**Addendum Number:** 01

**Addendum Issue Date:** February 1, 2021

**Project Name:** CMH Ortho Clinic Addition and Renovation

**Project Number:** 0200707.00

1000 N Allen Street  
Robinson, IL 62454

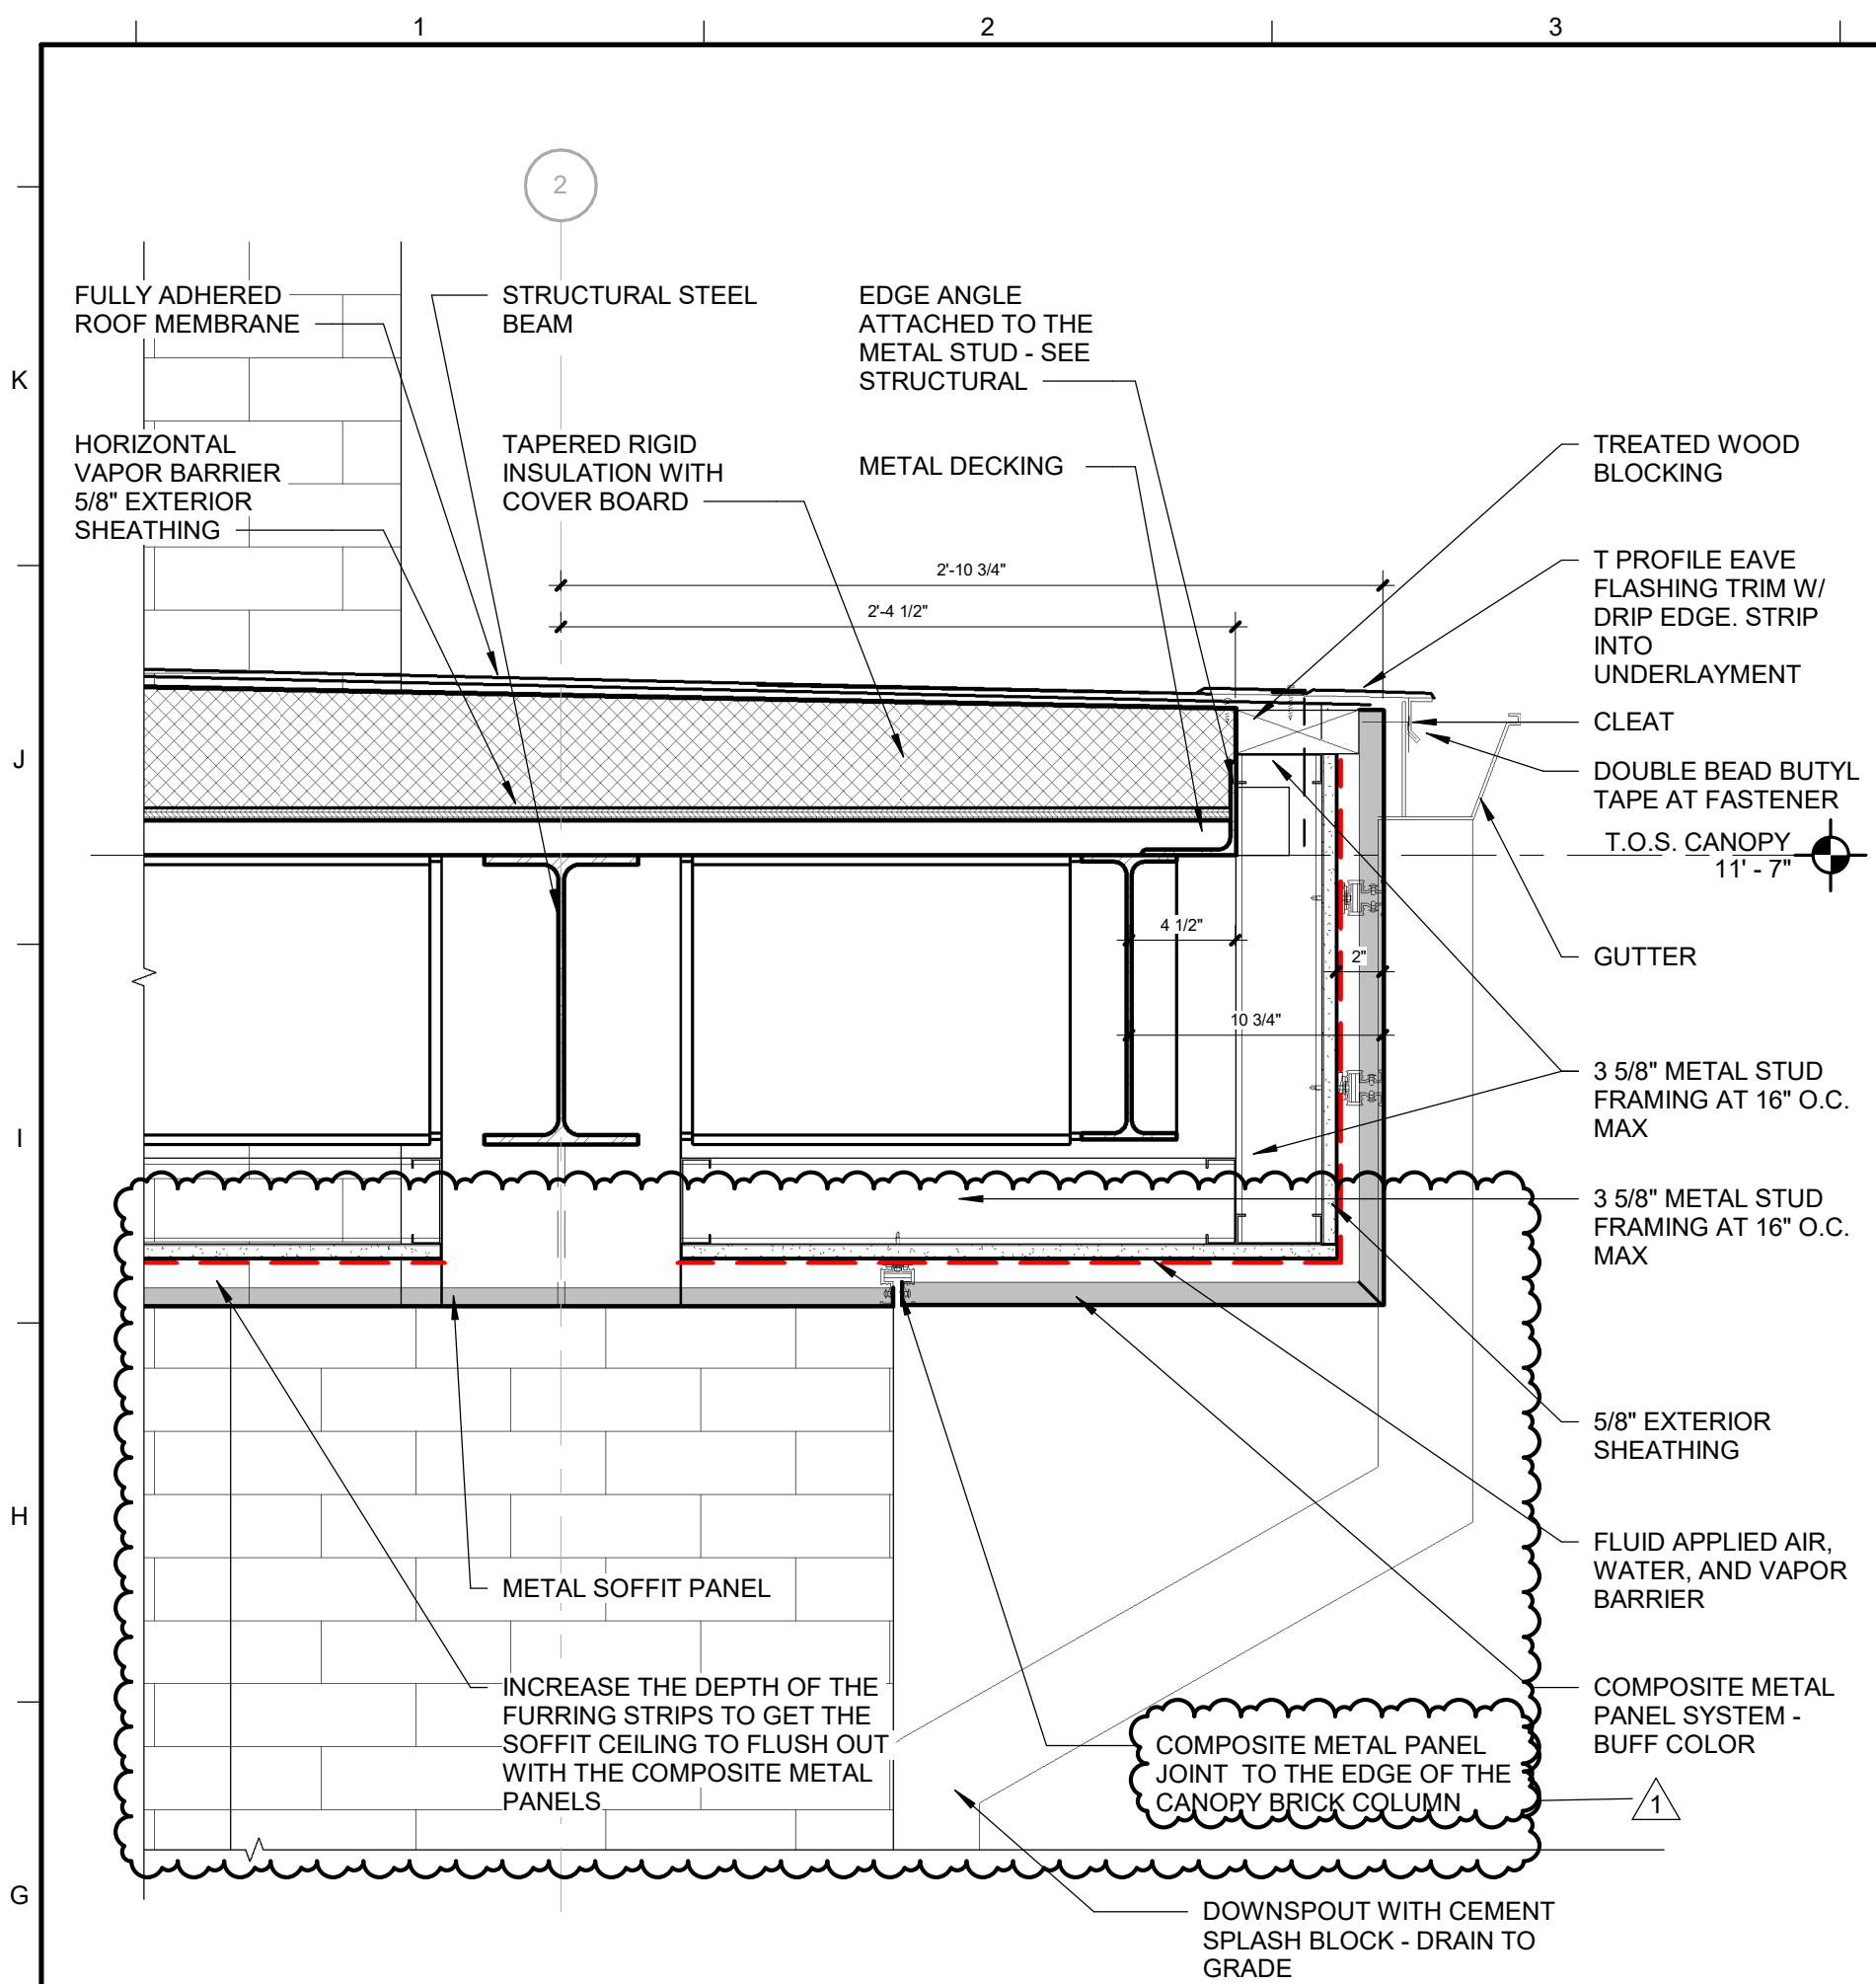
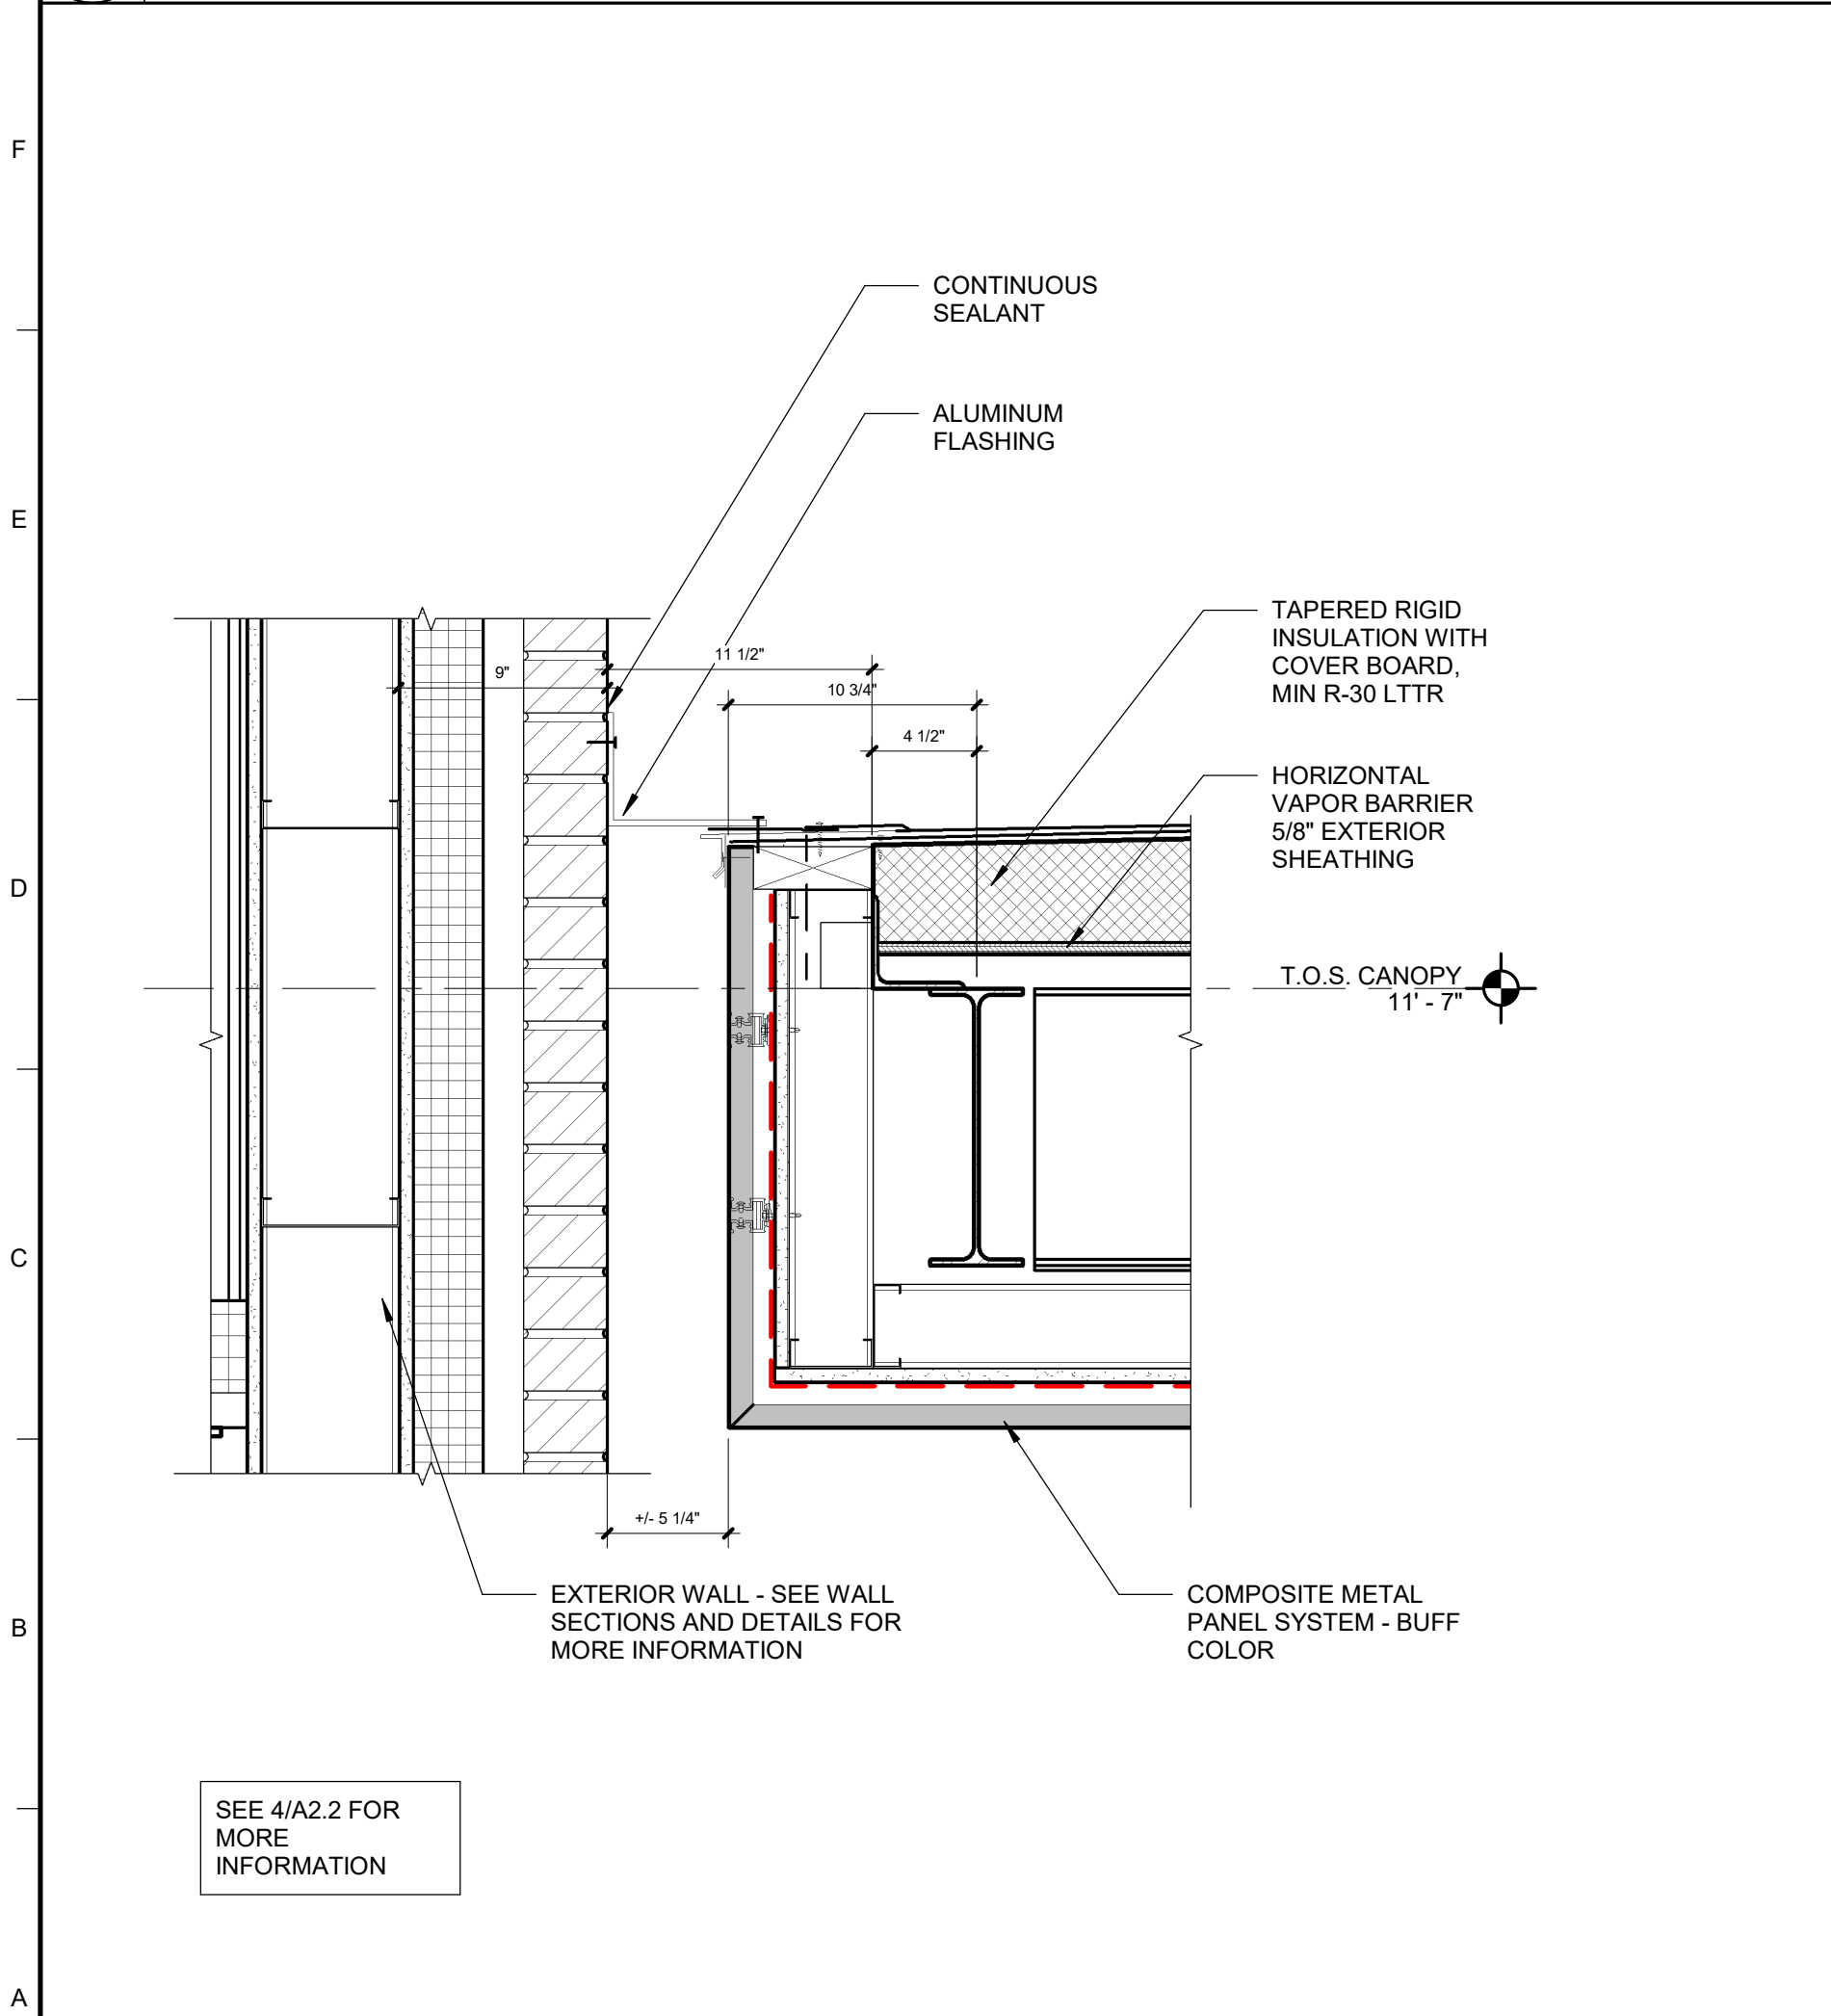
7. Sheet A2.4 – ENLARGED VESTIBULE PARAPET SECTIONS AND CANOPY DETAILS

- a. REVISE composite metal panel joint to the edge of the canopy brick column, as shown on the attached reissued sheet.
